40GBASE-T

Link Segment Specifications

Comments to D0.8

- 40GBT Link Segment IL

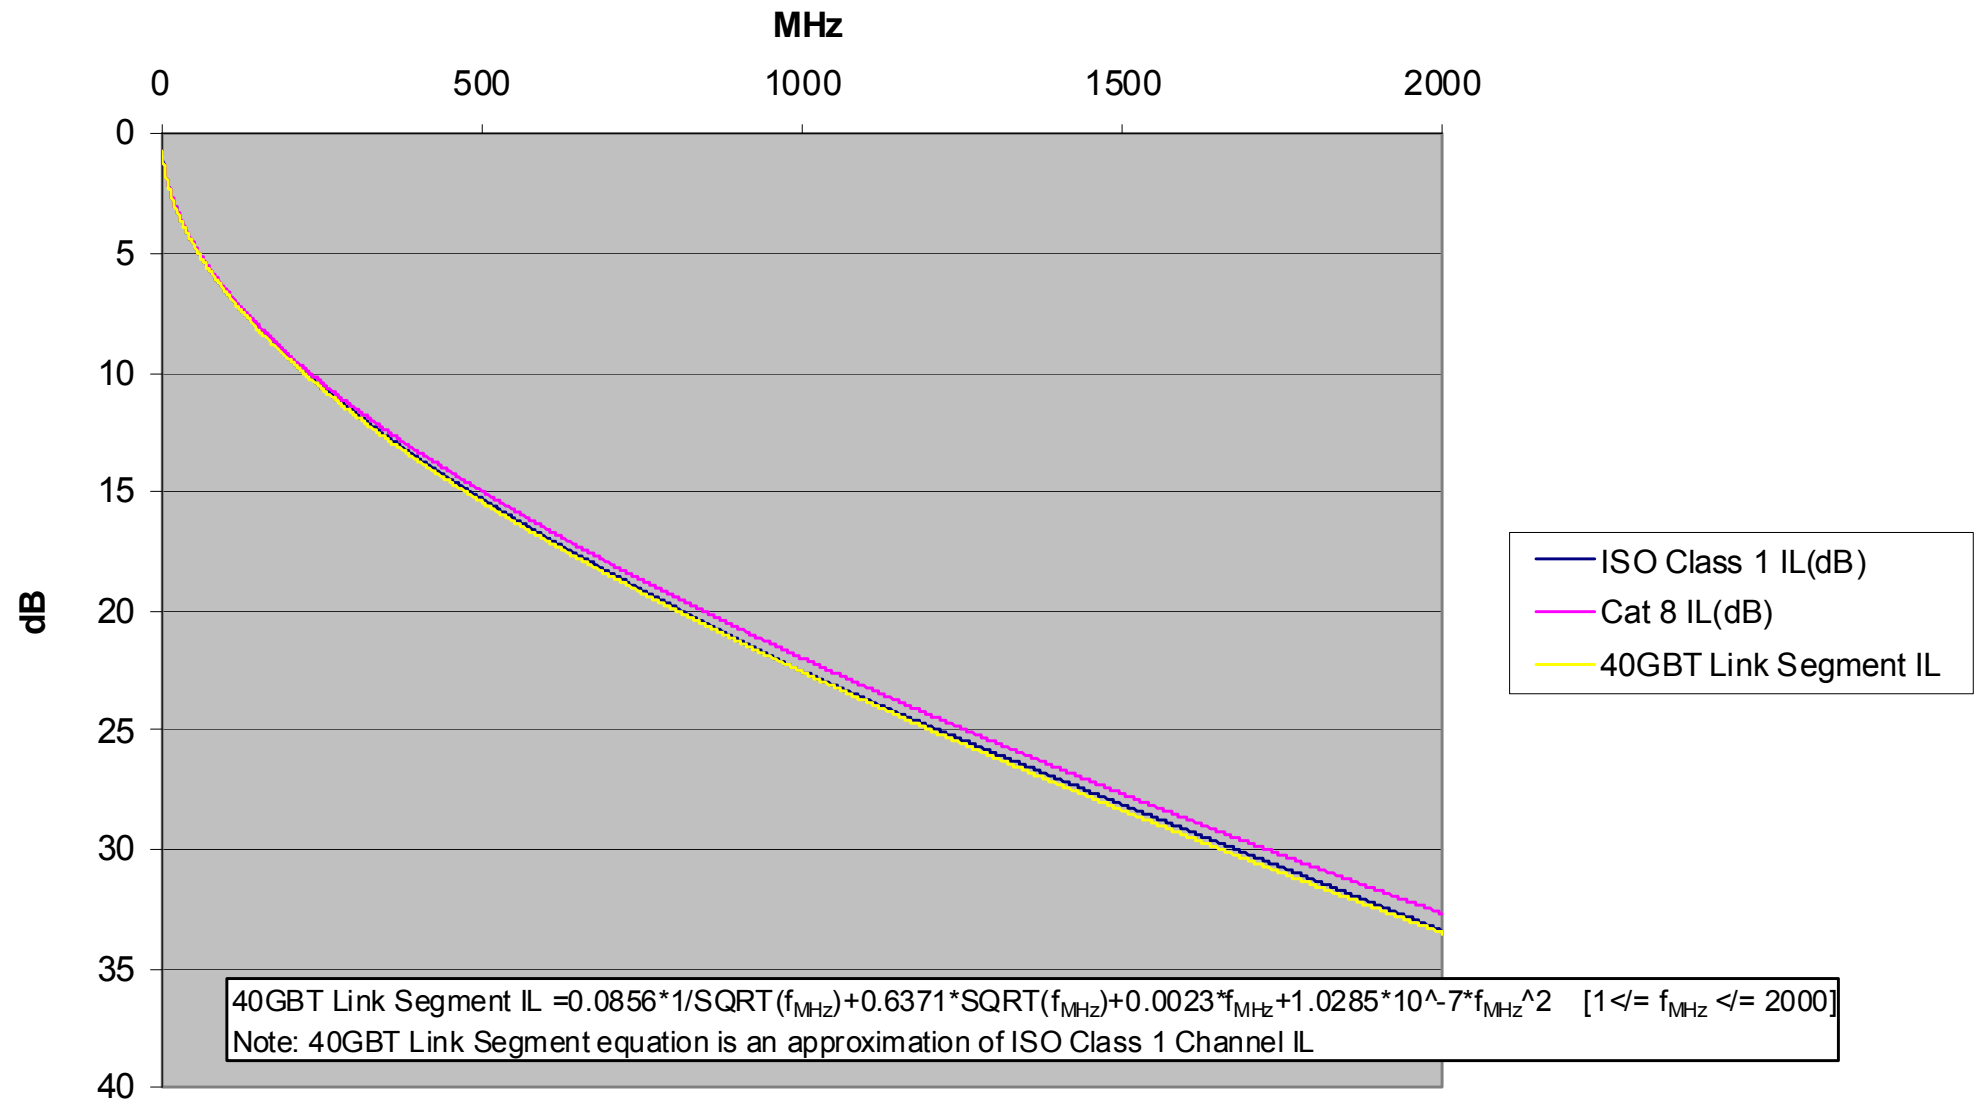
- The insertion loss of each duplex channel using Equation (98–11) to Equation (98–14) unnecessarily complex. Equation can be simplified by regression.
- Link segment insertion need not implicitly represent cable and connector insertion losses.

- 98.7.2.1 Insertion loss proposal

- replace Equation (98–11) to Equation (98–14)

$$=0.0856*1/\text{SQRT}(f_{\text{MHz}})+0.6371*\text{SQRT}(f_{\text{MHz}})+0.0023*f_{\text{MHz}}+1.0285*10^{-7}*f_{\text{MHz}}^2$$

[1<= f_{MHz} <= 2000]

- Add Note: 40GBASE-T Link Segment equation is an approximation of ISO Class 1 Channel IL
